**BUILDING CONSENT RFI BC: 170818**

**BUILDING CONSENT RFI BC: 170818**  
**155 Field Way, Waikanae**

Project Name:  
**155 Field Way Cladding Remediation**

Project Address:  
**155 Field Way Waikanae Beach**

Drawing Title: <b>Proposed Elevations Rev A</b>	
Project Number: R17104	Status: BC and Tender
Date: 23/11/2017	Scale: As Shown   Size: A3
Drawing No. <b>211</b>	Revision No. <b>A</b>

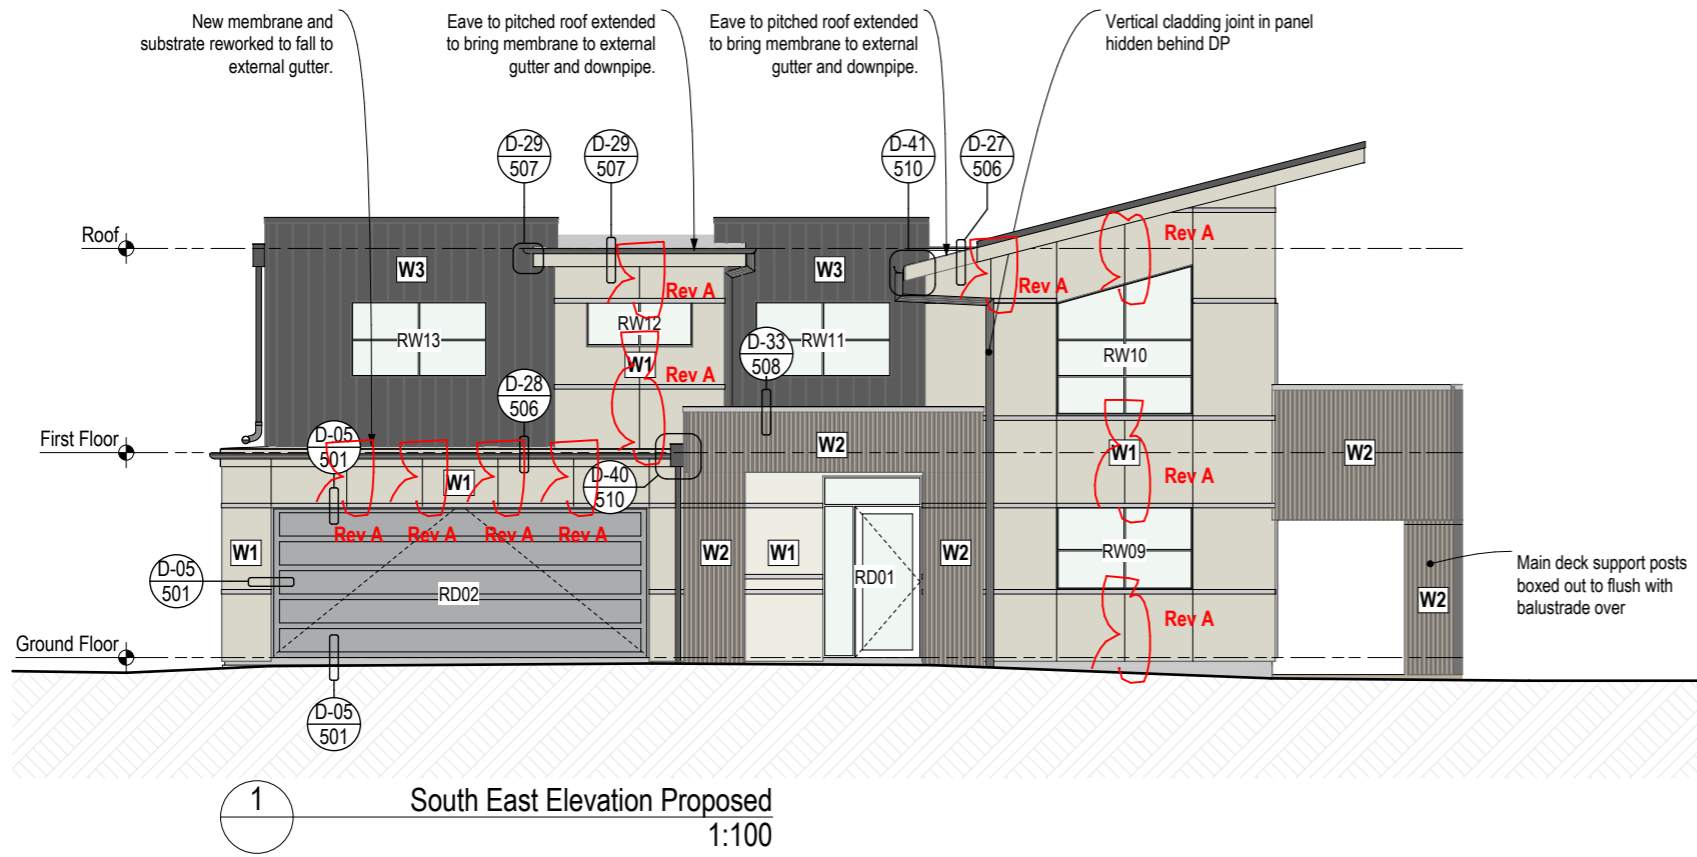
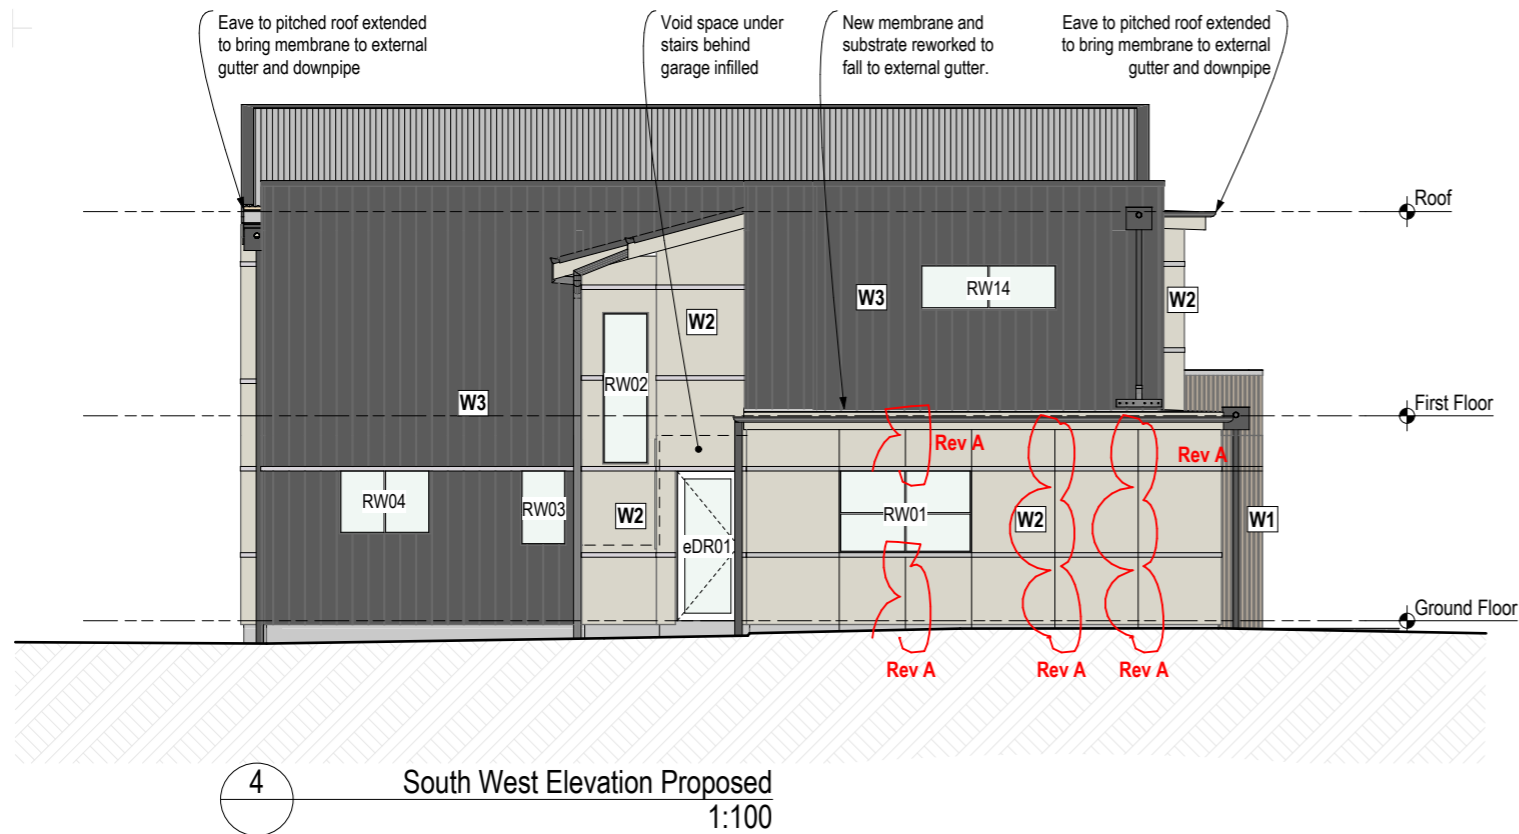
Response: See attached Espan 340 loadspan table and Espan 340 Installation details. Updated details on dwg 500 Rev A, 502 Rev A & 505 Rev A.			JOH
Plywood sheet	Pass	<p>The ply cladding is shown fixed horizontally to various areas, this is not in accordance with the manufacturers technical specification requirements (ref section 4.5 the document). Note: Provide a copy of the current Shadowclad Specification and Installation Guide and revise the details proposed on the architectural DWGs to comply with those in the document. This may require</p>	JOH

4. Note updated to refer to specification section 3897 and QAP, dwg 100 Rev A
5. Panel set out has been amended to show panels fixed vertically – refer to dwg 210 Rev A & 211 Rev A. Shadowclad specification attached "CHH Shadowclad Specification and Installation Guide." Updated dwg 501 Rev A, 502 Rev A, 504 Rev A.

D-27  
Membrane - Barge to Match P.M Roof  
1:5

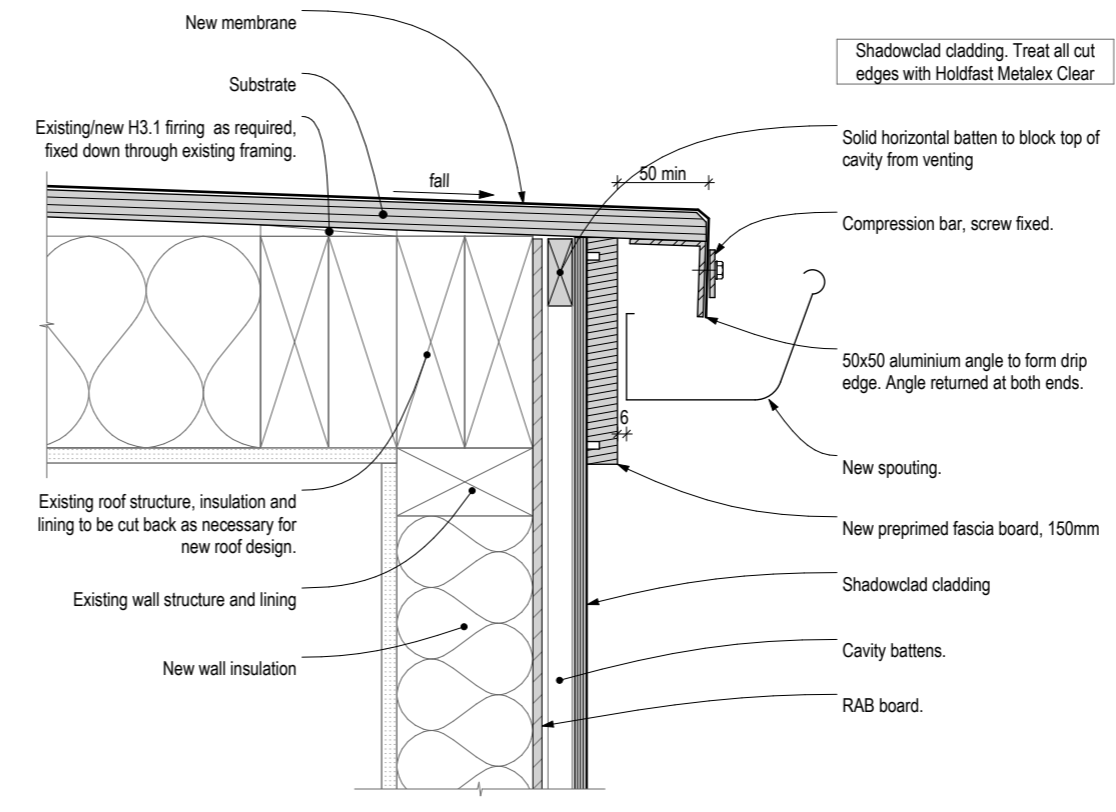
12) DWG 506 D-27 - This detail cannot be used as proposed as the flashing edge will cut in to the membrane – **Part relates to item 8**

12. Refer to detail, updated to standard compression bar termination that will lap under the barge flashing to the corrugated roof section above.
13. Refer to dwg 506 Rev A, D-26

Membrane - Existing to New Junction  
1:5

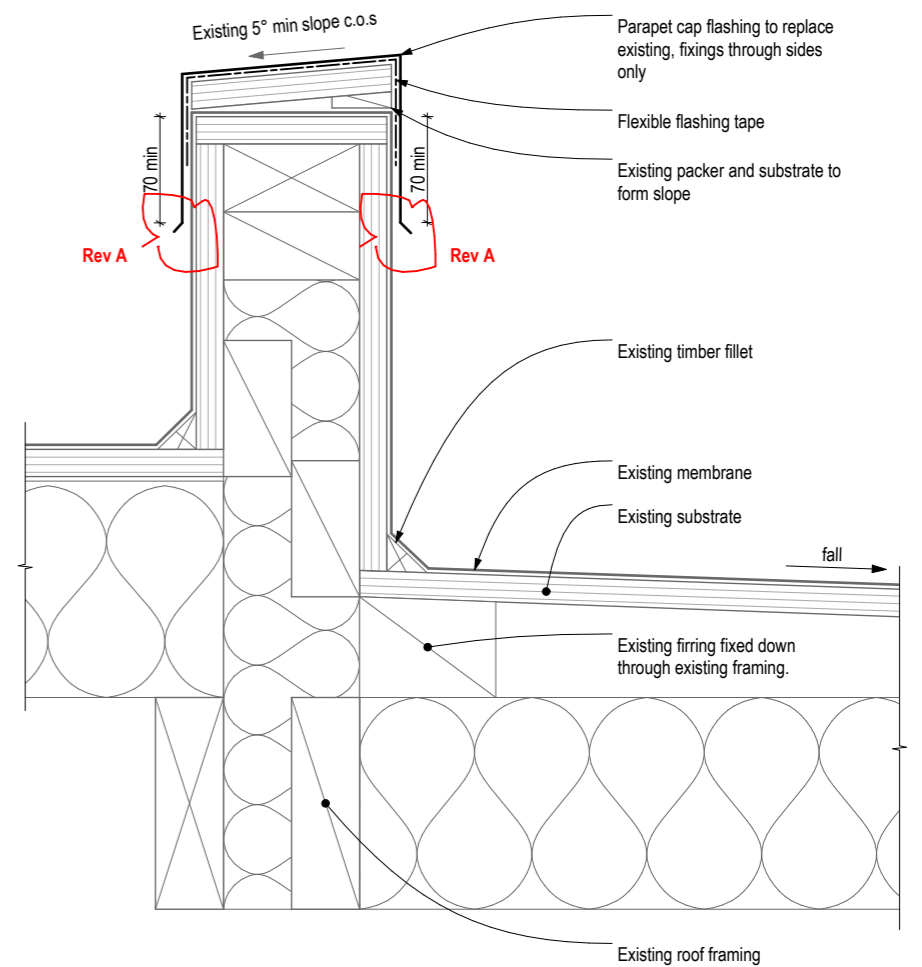
8) DWG 507 D-31 - Provide confirmation from Viking the method proposed at the lap joint with the existing membrane is acceptable for the product and installation warranties to be valid. Note: this may require some addition blocking to be installed where the substrate depth has been reduced. **They will also need to confirm the H 3.1 corner fillet is acceptable.**

8. Lap detail updated. It has been reviewed and confirmed by Viking: 22/11/17: *"I have reviewed the detail and can confirm that it is acceptable."* – Chris Withers – Territorial Manager at Viking Roofspec. Confirmation from Viking attached.
